**STAFF RECOMMENDATION
250 Harding Place (0 Harding Place)
November 20, 2019**

Application: New Construction—Infill and Outbuilding
District: Belle Meade Links Triangle Neighborhood Conservation Zoning Overlay
Council District: 23
Base Zoning: R10
Map and Parcel Number: 13001014100
Applicant: Chris Goldbeck, P. Shea Design
Project Lead: Paul Hoffman; paul.hoffman@nashville.gov

<p>Description of Project: This application is for construction of a new residence and detached outbuilding.</p> <p>Recommendation Summary: Staff recommends approval with the conditions:</p> <ol style="list-style-type: none"> 1. The finished floor height shall be consistent with the finished floor heights of the adjacent historic houses, to be verified by MHZC staff in the field; 2. Staff approve a brick sample, color of roofing, windows, doors and garage doors, walkways and driveway; and, 3. HVAC and utilities shall be located behind the house or on either side, beyond the mid-point of the house. <p>With these conditions, Staff finds that the proposed infill and outbuilding meet Section II.B for New Construction of the Belle Meade Links Triangle Neighborhood Conservation Zoning Overlay.</p>	<p>Attachments

Figure 1: Vacant lot at subject property.

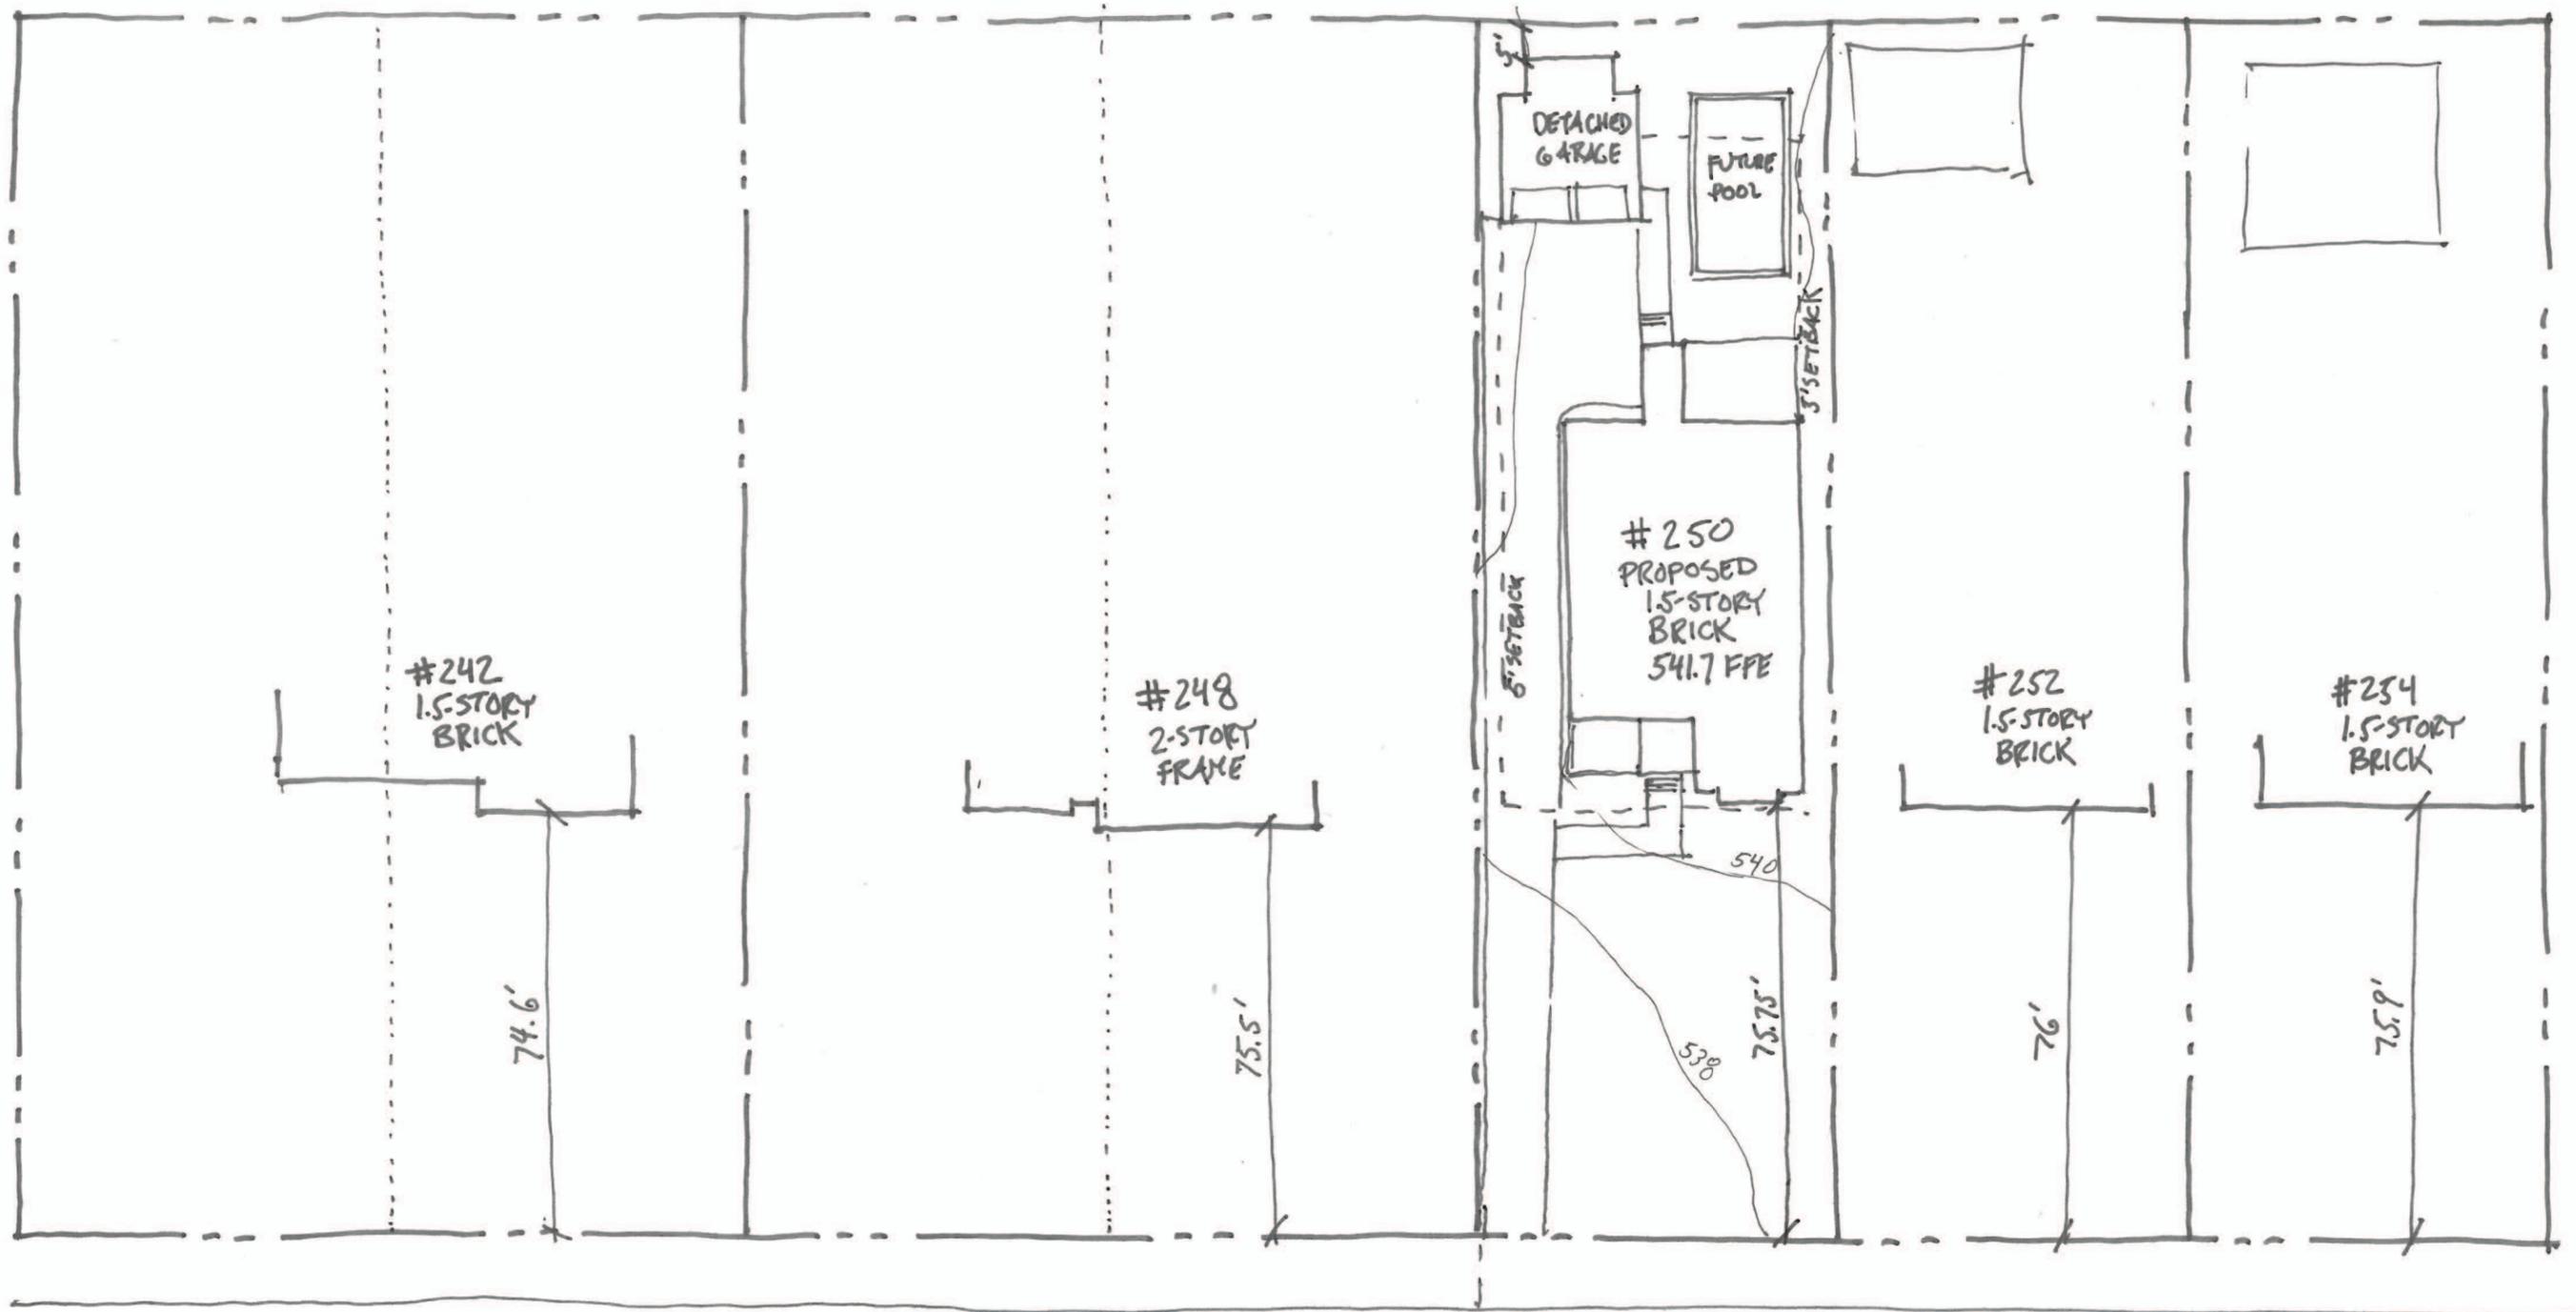
Background: 250 Harding Place (0 Harding Place) is a vacant lot in the Belle Meade Links Neighborhood Conservation Zoning Overlay.

SITE PLAN
1:30

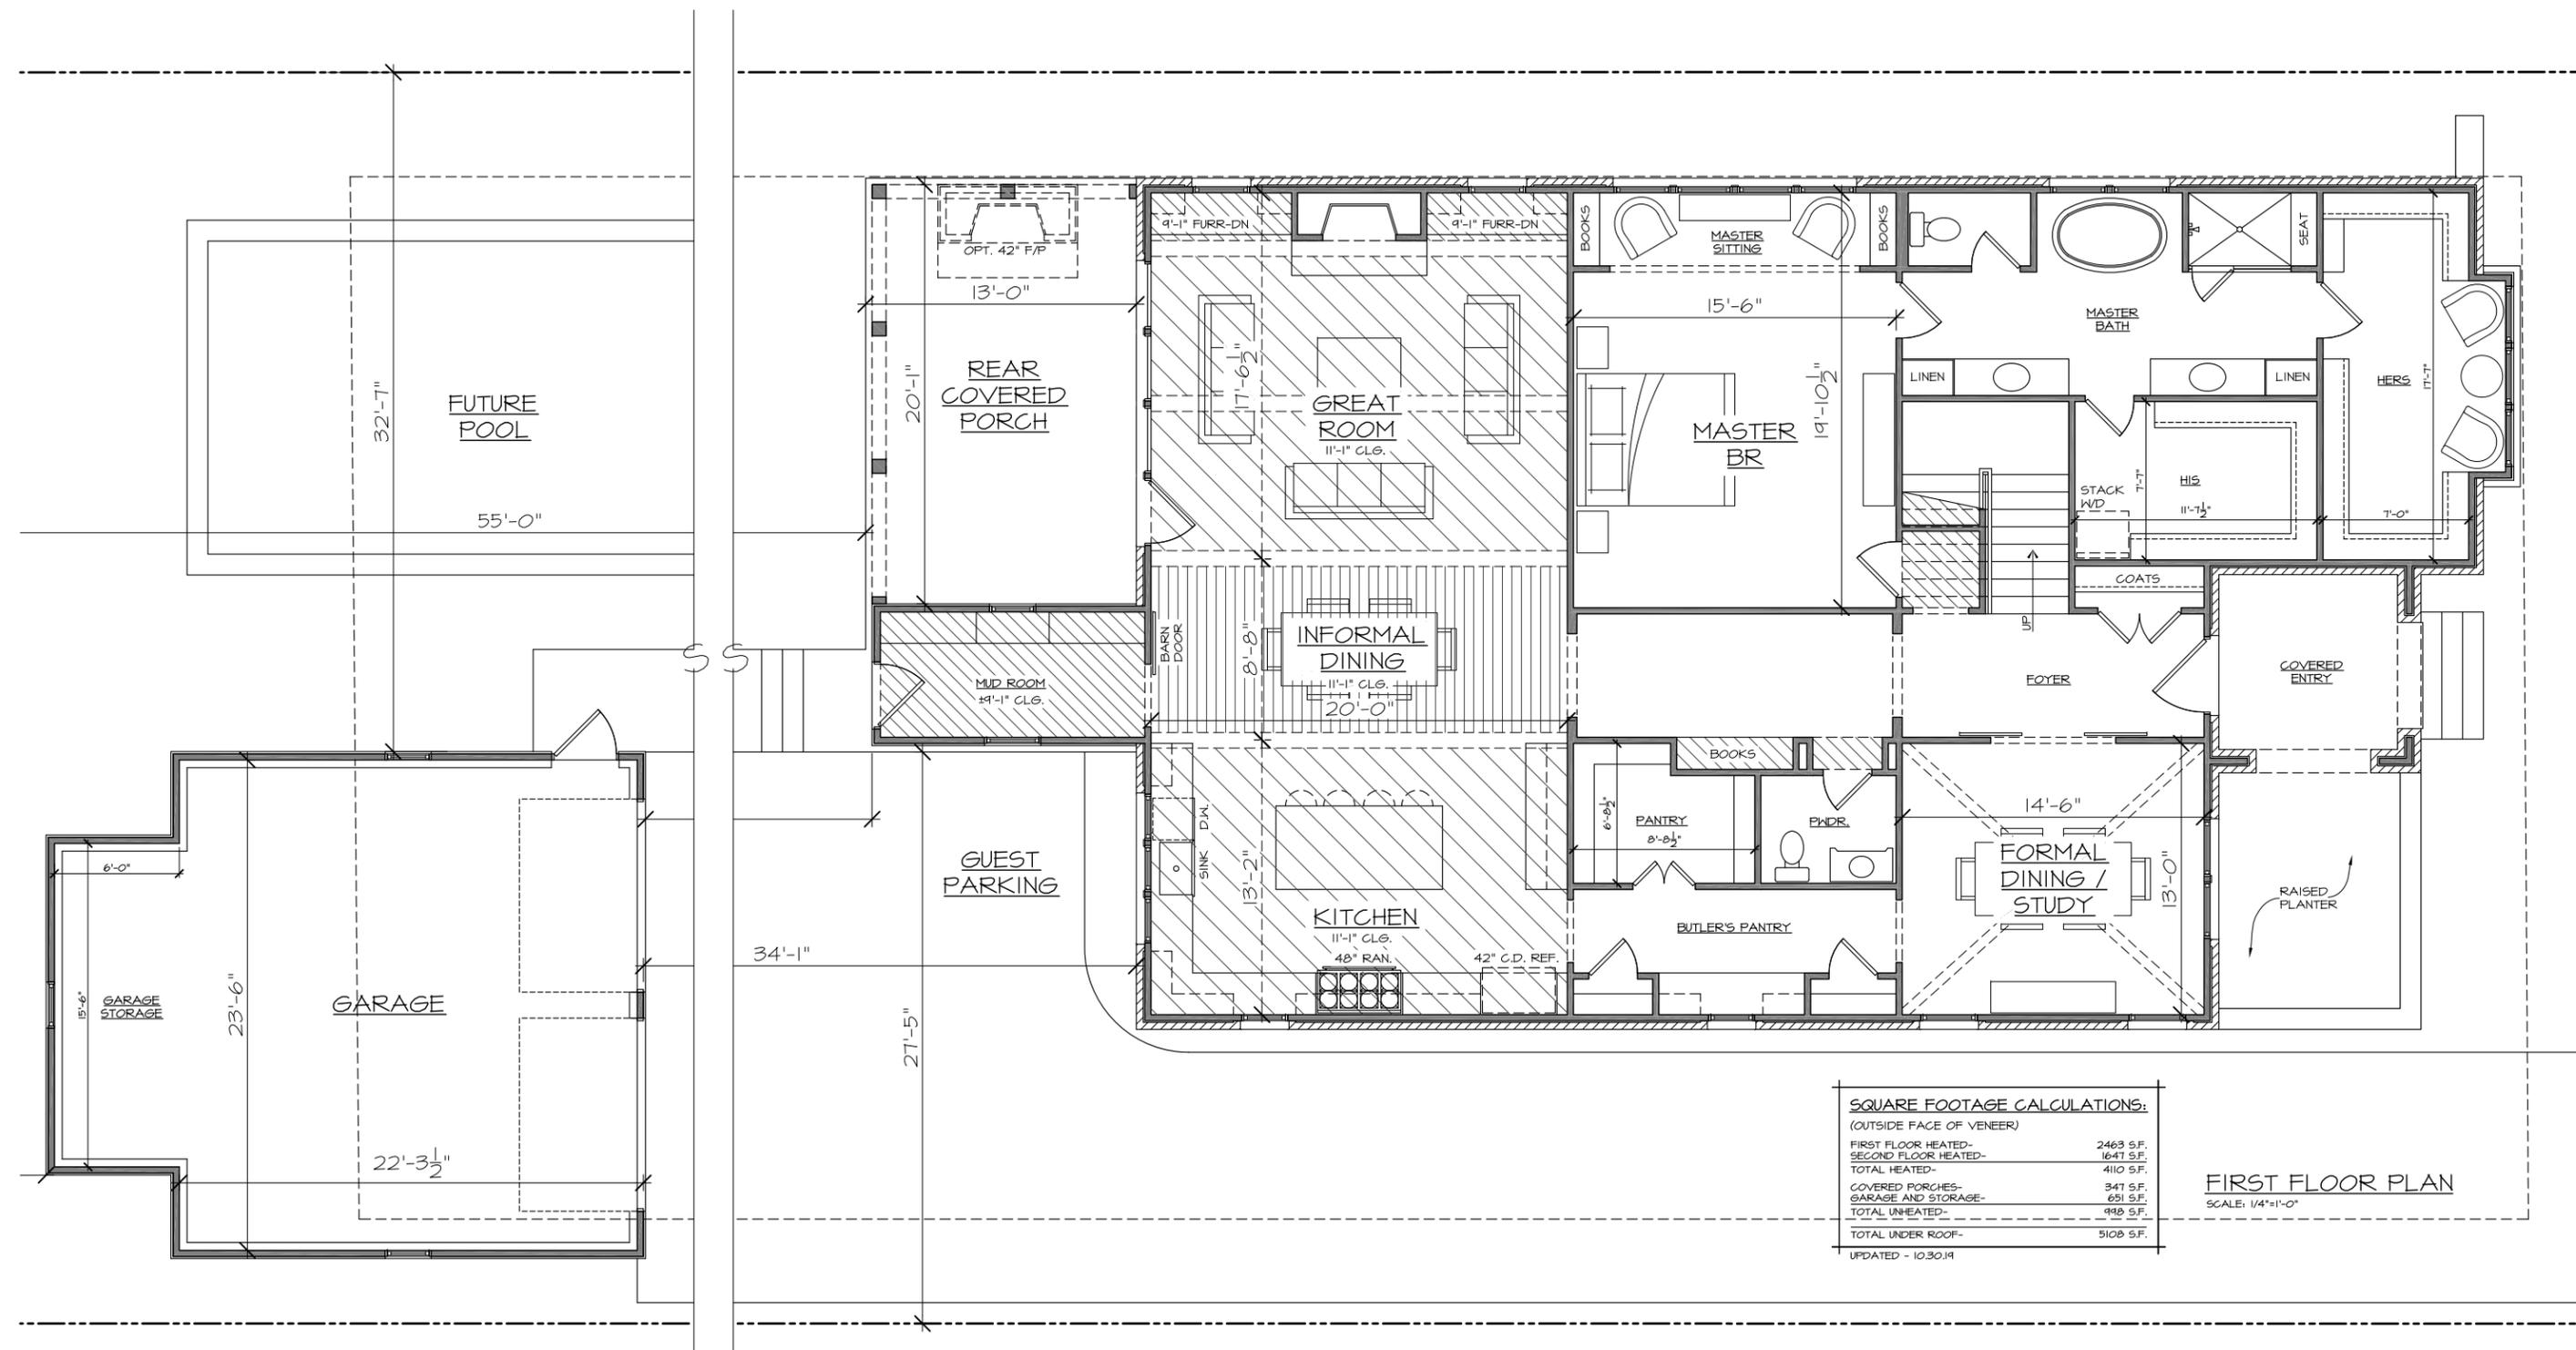
Setback & Rhythm of Spacing: The proposed infill will meet all base zoning setbacks. It is set fourteen feet (14’) from the left property line and five feet (5’) from the right property line, meeting the requirements of five feet (5’) for each side. Homes offset on the lot are typical in this district to accommodate driveways. The rear of the house will be approximately fifty-five feet (55’) from the rear property line, meeting the minimum requirement of twenty feet (20’).

The front setback is proposed to split the setback of the neighboring homes at seventy-five feet, five inches (75’ 5”). Staff finds the front setback to be appropriate. Staff finds that the project’s setback and rhythm of spacing meet Section II.B.c of the Belle Meade Links design guidelines.

Orientation: The proposed infill is appropriately oriented to face Harding Place. The front entry has a covered front porch that is ten feet (10’) deep. Vehicular access to the site is via a new curb cut and driveway to the left of the house. The driveway will extend all the way to the new outbuilding to the rear of the infill. An L-shaped walkway connects the front porch to the driveway, which is typical of homes nearby. Staff finds that the project’s orientation meets Section II.B.f.

Appurtenances & Utilities: A new twelve foot (12') curb cut and ten foot (10') driveway will be added to the left side of the lot, which staff finds to be appropriate in this neighborhood. The location of the HVAC and other utilities was not noted. Staff recommends that the HVAC be located on the rear façade, or on a side façade beyond the midpoint of the house. With staff's approval of the HVAC and utilities locations, staff finds that the known appurtenances meet Section II.B.i.

1. The finished floor height be consistent with the finished floor heights of the nearby historic houses, to be verified by MHZC staff in the field;
2. Staff approve a sample of masonry, roof color, windows, doors and garage doors, driveway and walkway prior to purchase and installation; and
3. The HVAC be located behind the house or on either side, beyond the mid-point of the house.

LEFT SIDE ELEVATION
 SCALE: 1/4" = 1'-0"

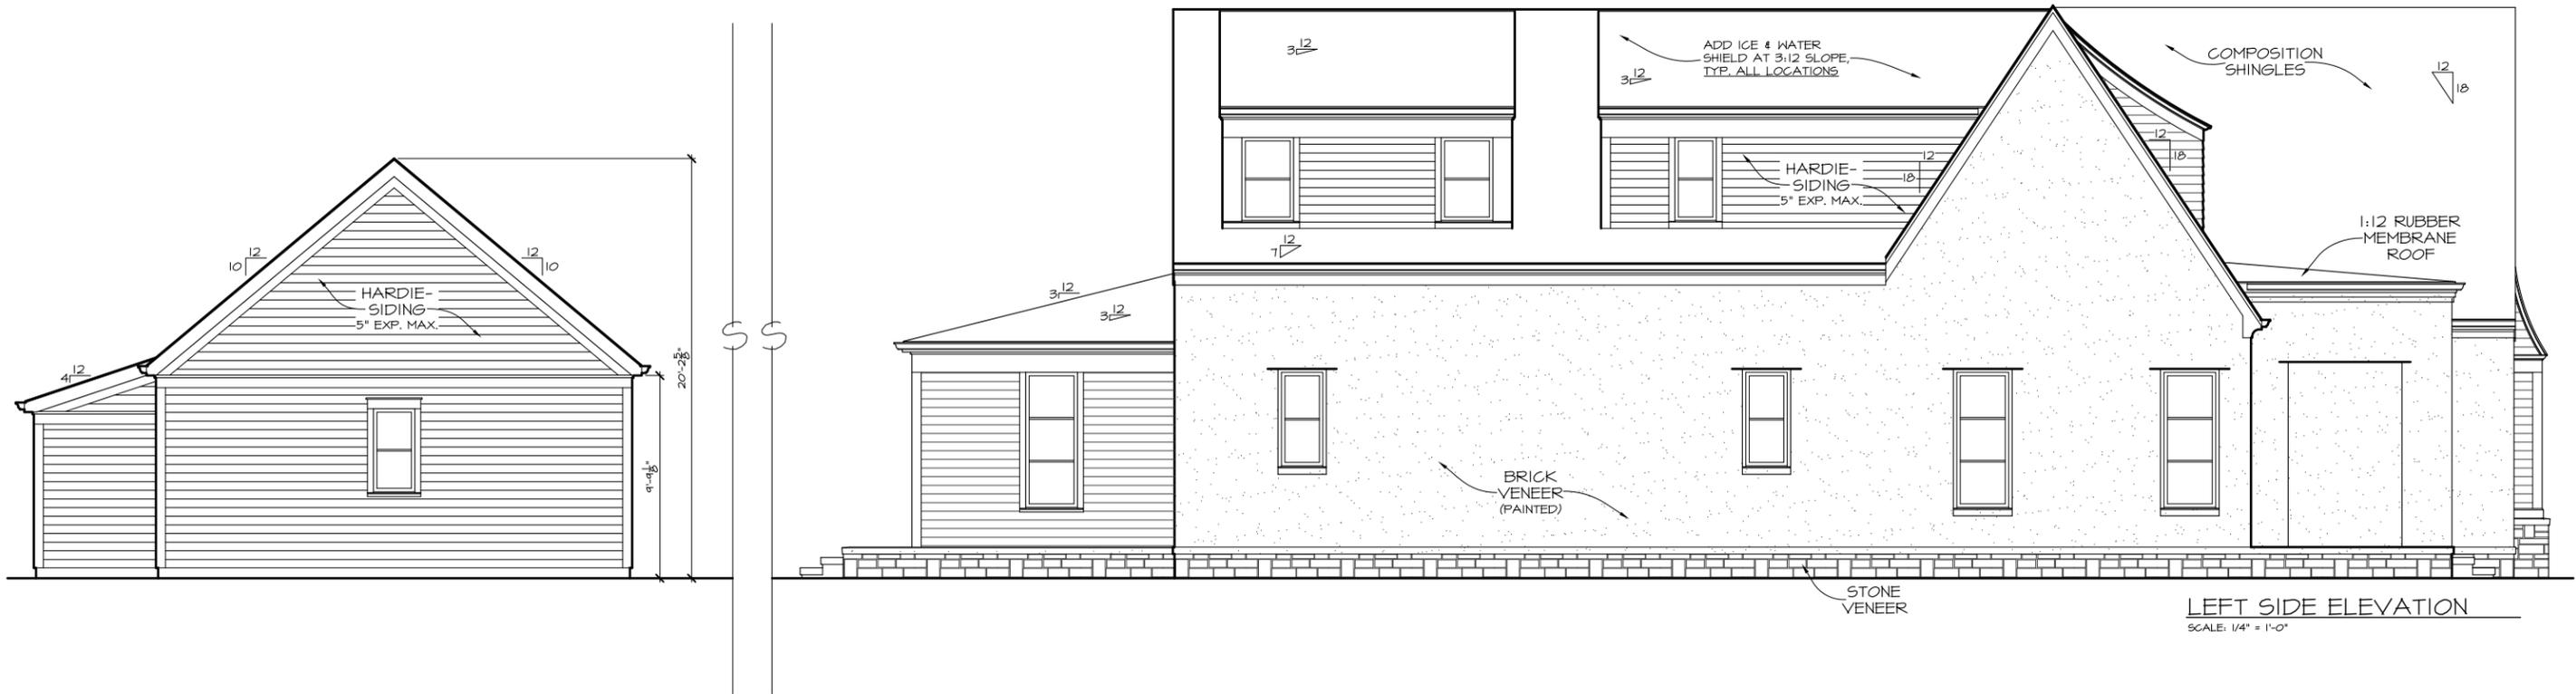
Proportion and Rhythm of Openings: The proposed windows are generally twice as tall as they are wide, thereby meeting the historic proportion of openings. The left side has an expanse of wall space of approximately twenty feet (20’) without a window or door opening. The design guidelines allow for leniency for a minimally-visible side or rear wall. As this is toward the rear of this side of the house, staff finds the fenestration appropriate. The double, triple and quadruple windows include four to six inch (4”-6”) mullions between windows. Staff finds the project’s proportion and rhythm of openings meet Section II.B.g.

FRONT ELEVATION
 SCALE: 1/4" = 1'-0"

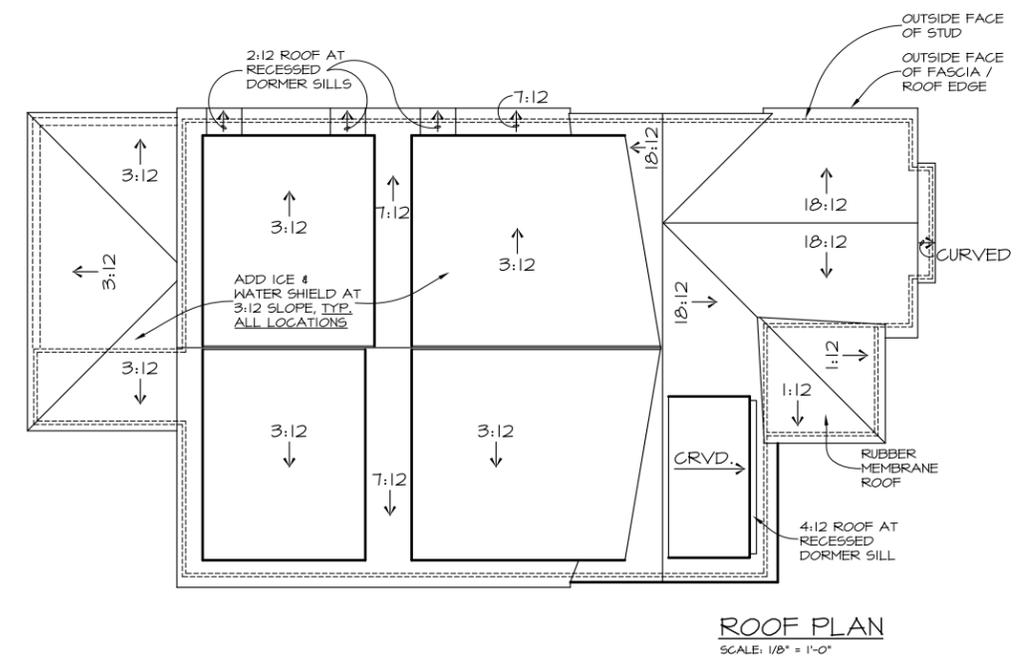
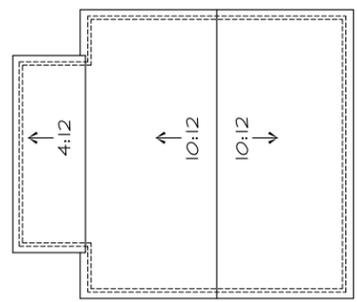
Height & Scale: The proposed infill is one-and-a-half stories with a ridge height of twenty-seven feet, six inches (27’ 6”) from grade. The eave height will be twelve feet (12’) from grade. This is compatible with the heights of houses in the surrounding area, comprising mainly of one-and-a-half story houses with the tallest being twenty-eight feet (28’) tall. The foundation is two feet (2’) tall which is in keeping with the context, where foundation heights are from zero to three feet (0-3’). The infill will be forty-one feet (41’) wide, which staff finds to be appropriate and to meet the historic context, as historic houses in the area typically range between thirty-six feet (36’) and forty-six feet (46’) wide.

Staff finds that the height and scale of the proposed infill meets Sections II.B.a and II.B.b of the Belle Meade Links Triangle design guidelines. Staff recommends a condition of approval to verify the construction height of the foundation and floor systems in the field to ensure that the finished floor line of the new construction is compatible with the historic context. The project meets section II.B.1.a and b for Height and Scale.

Roof form: The house’s primary roof form is a cross gable with primary pitches of 18/12. The front and rear porch roofs have lower pitches, which is normal for porches historically. The front dormer has a curved roof and is inset two feet (2’) from the wall below, as is typically required. The side dormers have 3/12 pitch. The roof forms and pitches proposed are compatible with those of surrounding historic buildings. Staff finds that the project’s roof forms meet Section II.B.e.
